MIROMAR LAKES COMMUNITY DEVELOPMENT DISTRICT

Attached as supplemental information to Item 3 on the September 29, 2016 agenda concerning the FGCU/Center Place Roadway Improvement Plans are documents I received from Alico's engineer's/responses to various comments.

Re: Northeast Connector Road

Please accept this letter as a response to comments dated August 12, 2016.

2.0

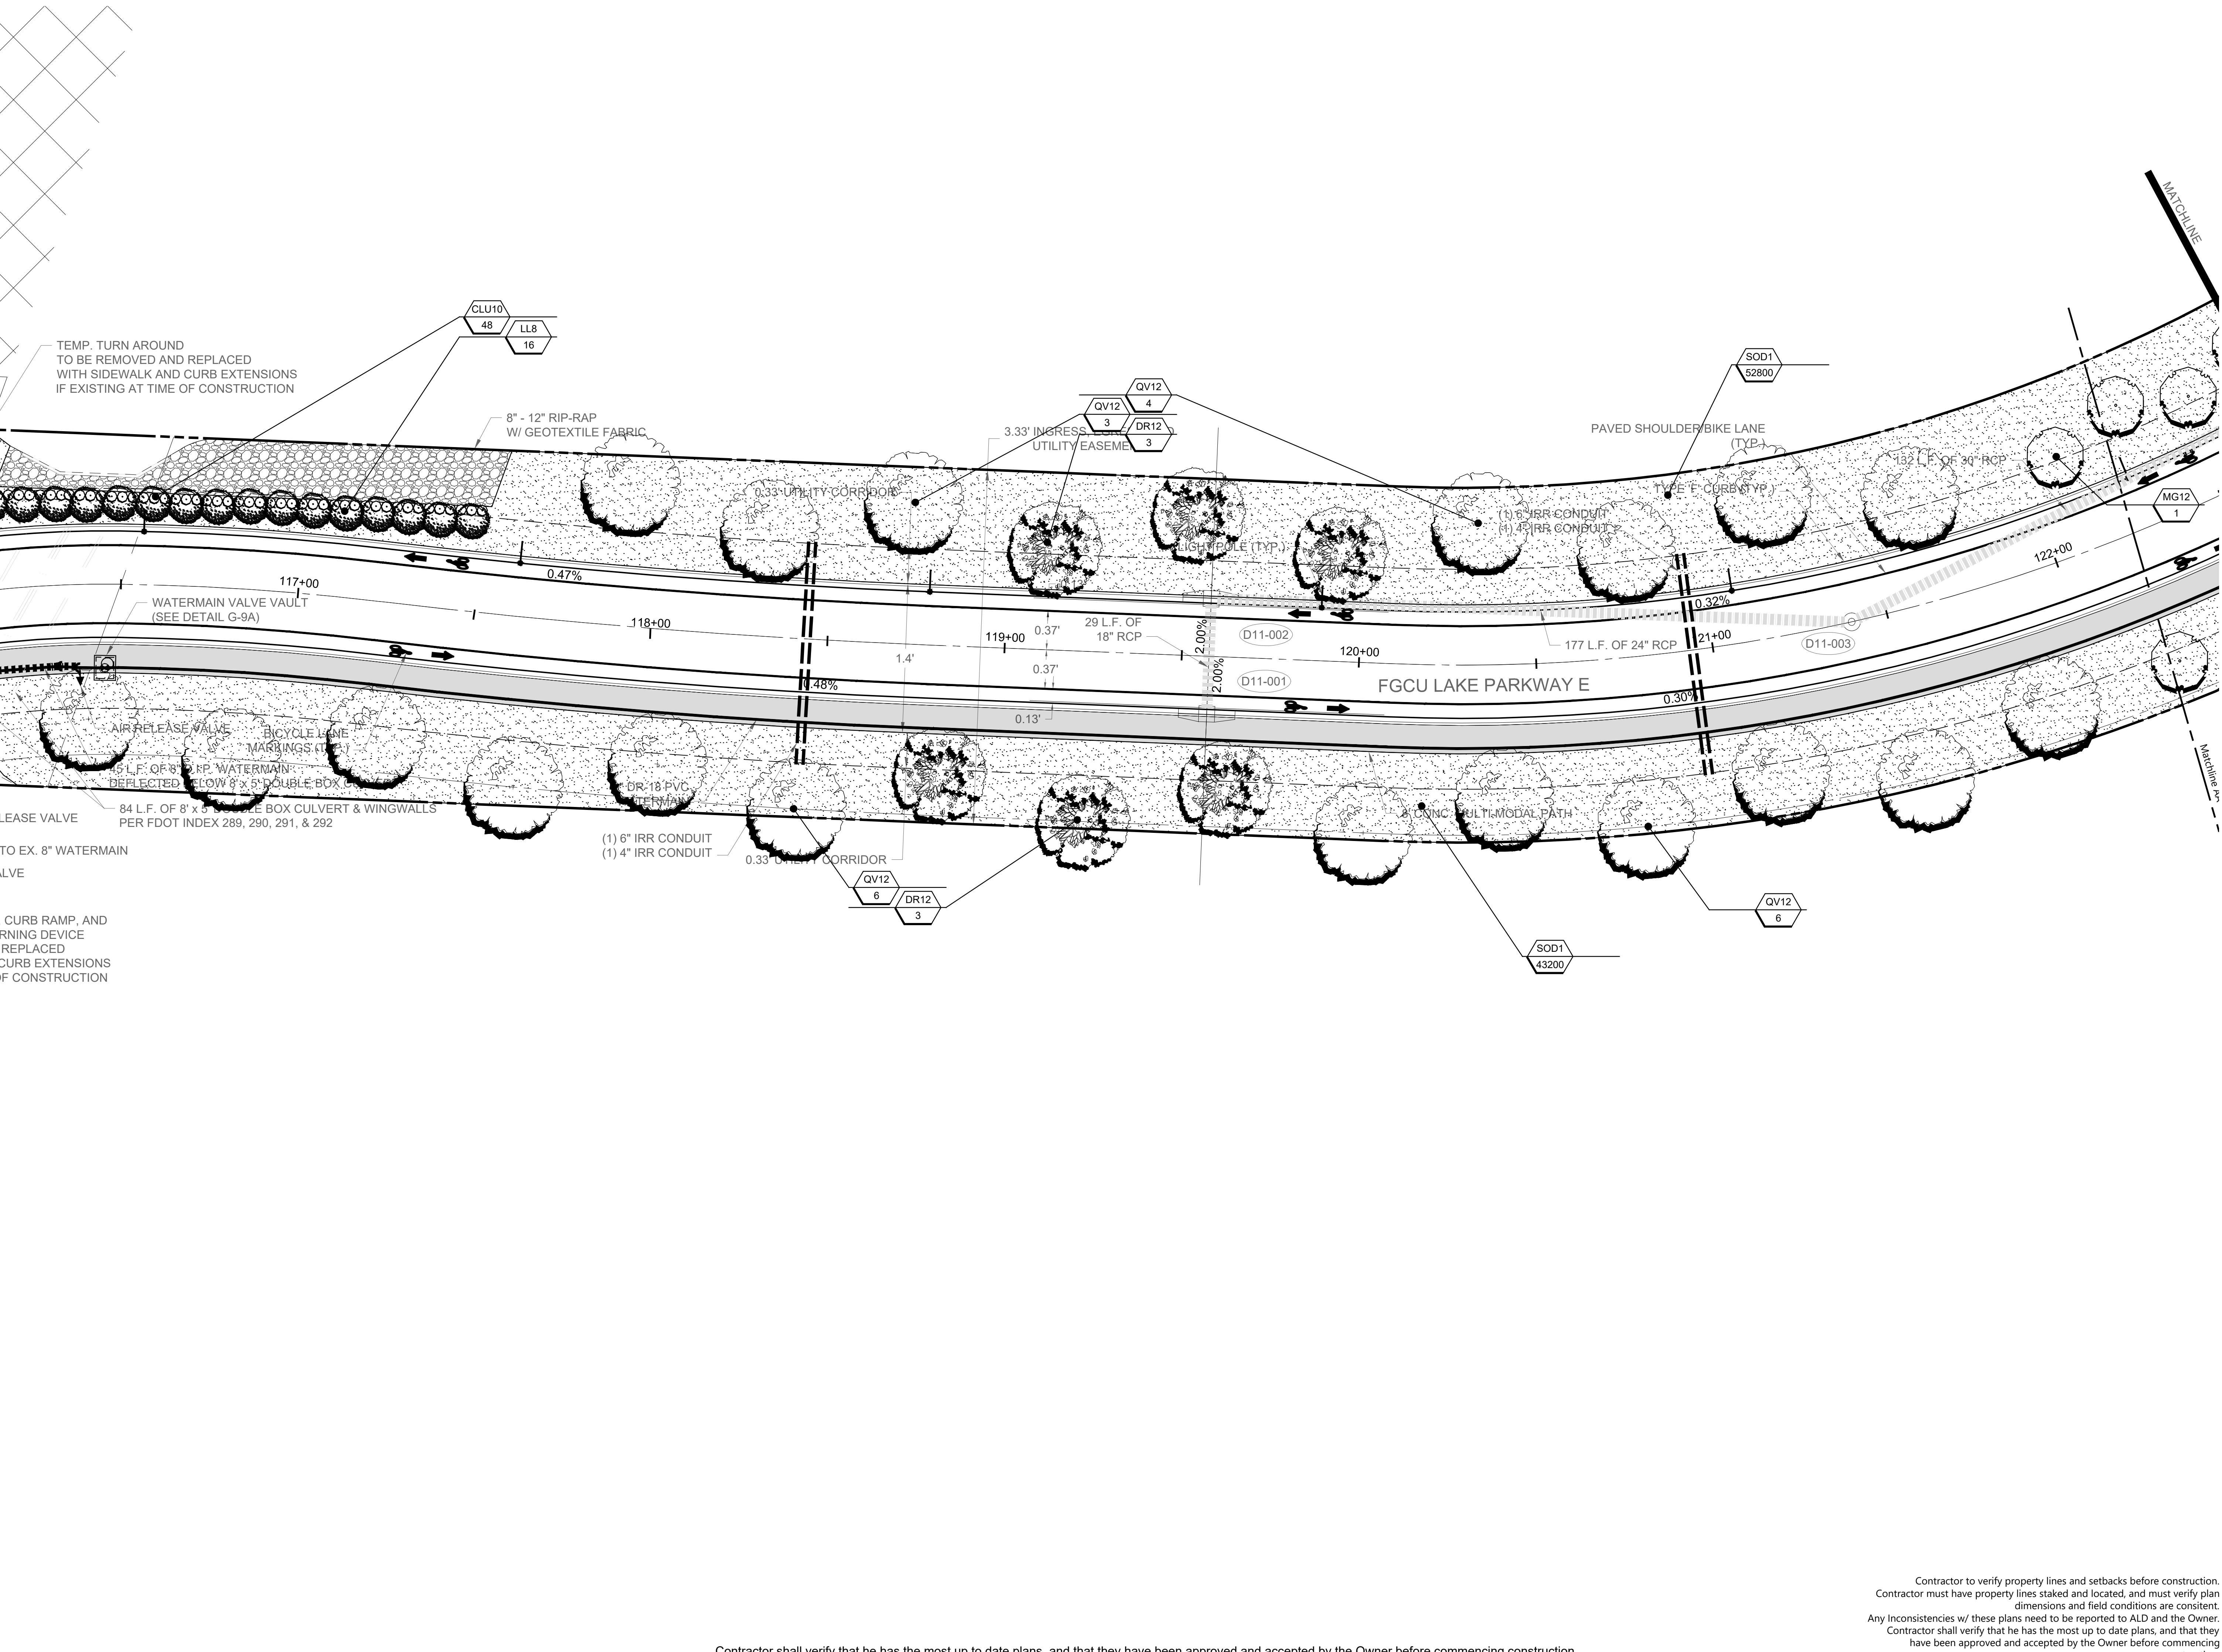
Sheet 2.1 – Please provide additional landscape detail demonstrating planting (canopy and hedge material) proposed to screen traffic from view corridors within Miromar Lakes. i.e., vegetation does not exist on the north side of the roadway at the crossing location.

The attached landscape plans have been updated to provide plantings adjacent to the water crossing in order to screen traffic from the Miromar Lakes view corridor.
